**PROJECT NO. 55718**

**RELIABILITY PLAN FOR THE  
PERMIAN BASIN UNDER PURA  
§ 39.167,**

**TEXAS INDUSTRIAL ENERGY CONSUMERS' COMMENTS**

Figure 2.2: S&P Global Permian Basin Peak Demand by Year

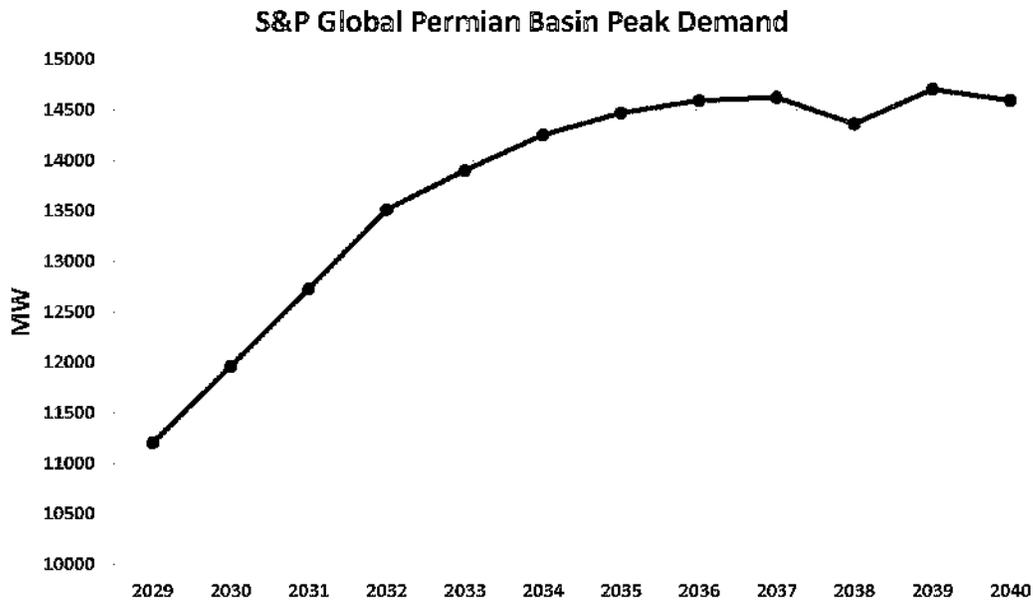
The Commission should approve a single, complete plan, rather than a phased plan. Critically, bifurcating the reliability plan into two phases increases the risk that the reliability plan will not meet the intended goals of HB 5066 in the near and long term. As explained previously, HB 5066 directed the Commission to work with ERCOT to develop a reliability plan for the Permian Basin,<sup>4</sup> which must *increase capacity to meet forecasted load* and reduce interconnection delays.<sup>5</sup> First, the phased approach is likely insufficient to meet the region's needs in 2030 because ERCOT failed to properly account for some of the assumptions in the S&P load growth forecast. As the S&P Global Permian Basin Peak Demand chart (copied below) shows, ERCOT assumed a load growth rate of approximately 6.4% during 2029 and 2032.<sup>6</sup> However, the steep increase in demand between 2029 and 2032 is artificial. Importantly, S&P assumed there would not be enough transmission to accommodate the existing need of oil and gas producers that would like to electrify and bring their operations onto the grid. As such, S&P spaced the load growth out between 2029 and 2032.<sup>7</sup> Under a bifurcated plan, ERCOT should have included the 2032 load as a part of the 2030 phase, instead of assuming a steady 6.4% increase in load levels year over

year. As a result of using the artificially low demand levels in S&P’s assumptions, it is unlikely that the 2030 phase can actually meet the needs of the region in 2030.
